Amendment No. 86
License No. DPR-71

ATTACHMENT TO LICENSE AMENDMENT NO. 86

SAFETY EVALUATION BY THE OFFICE OF NUCLEAR REACTOR REGULATION

SUPPORTING AMENDMENT NO. 86 TO FACILITY LICENSE NO. DPR-71

FIGURE 3 2 1-1

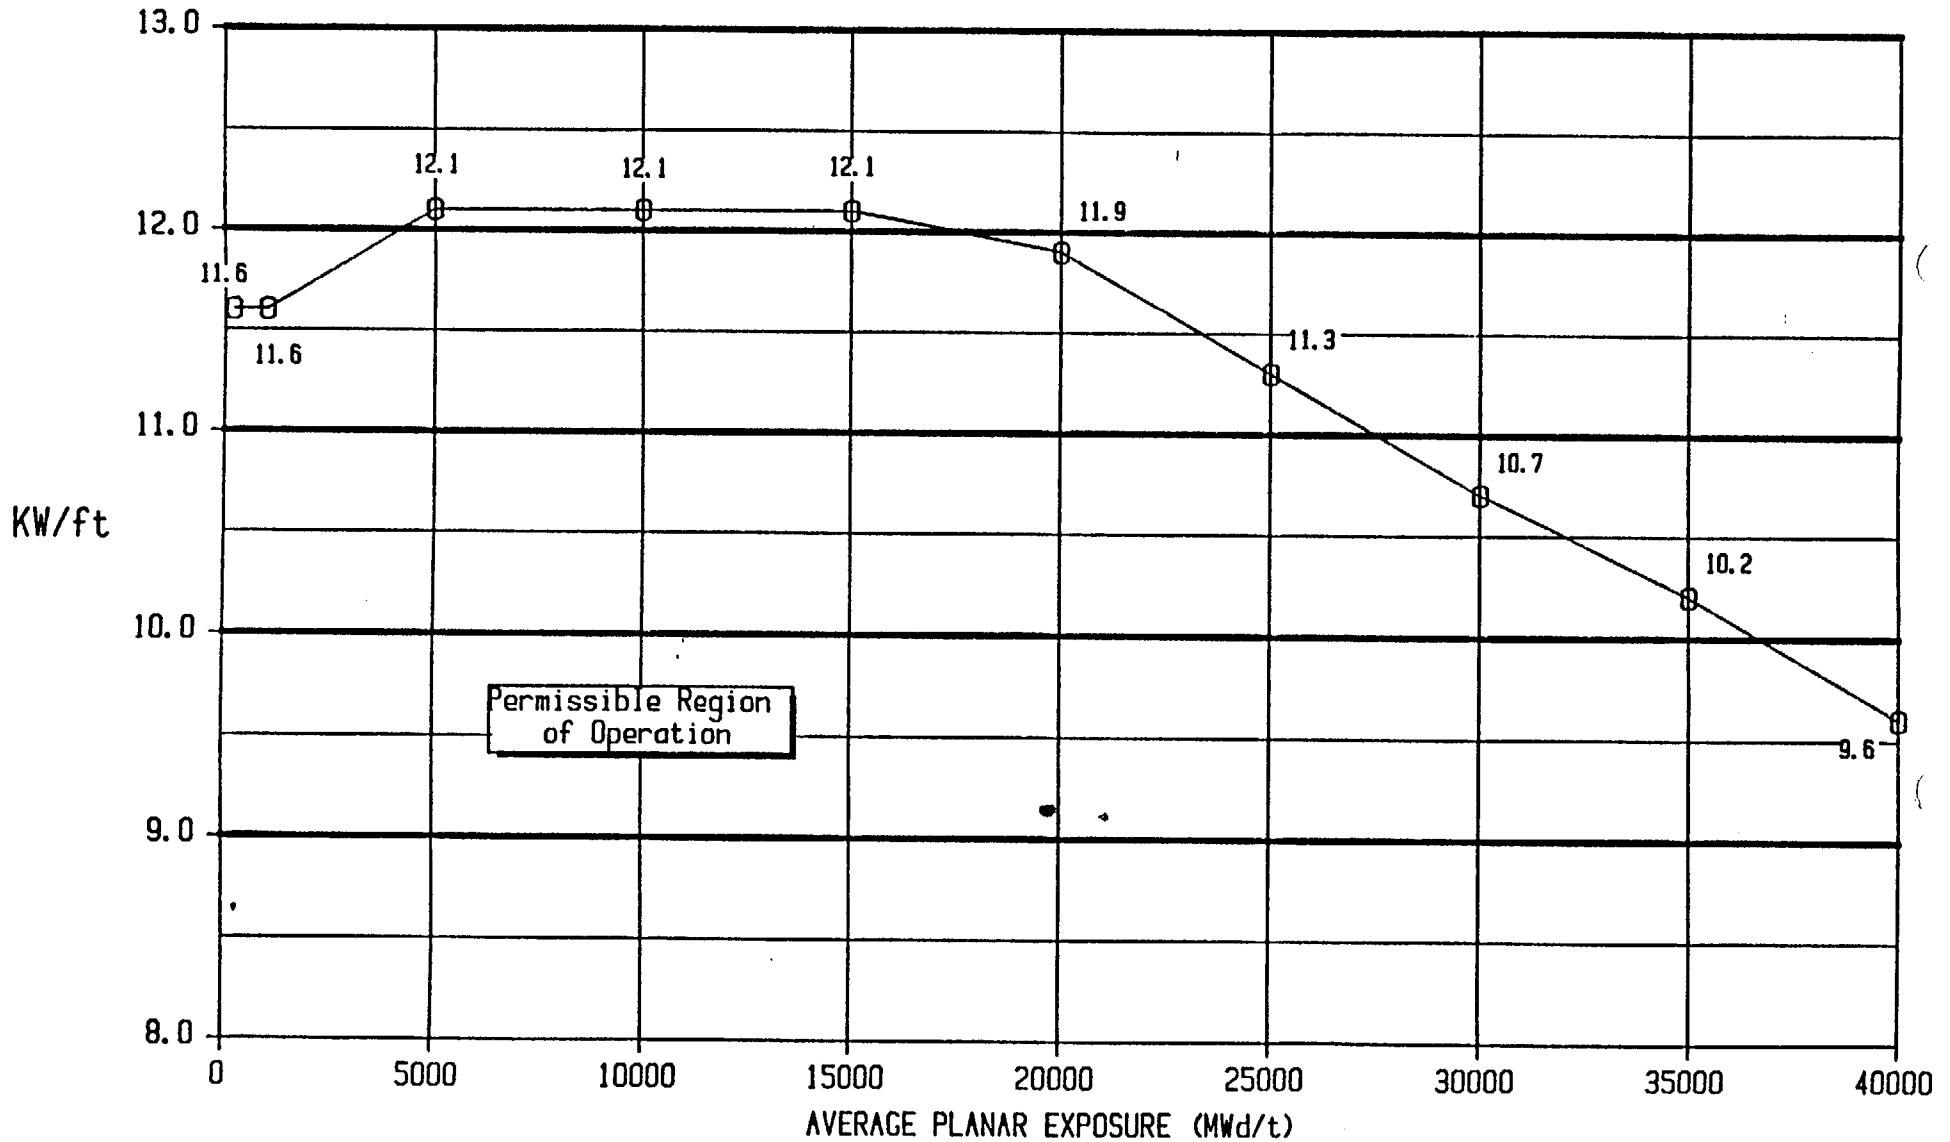
Changes were made in Figures 3.2.1-1 through 3.2.1-7 of the Technical Specifications in order to reflect the use of extended burnup to 40 GWd/ST for the 8x8R, P8x8R fuel types and 45 GWd/ST for the new BP8x8R fuel. We conclude that these changes regarding the proposed MAPLHGR limits are acceptable based on the discussion in Section 2 of this Safety Evaluation.
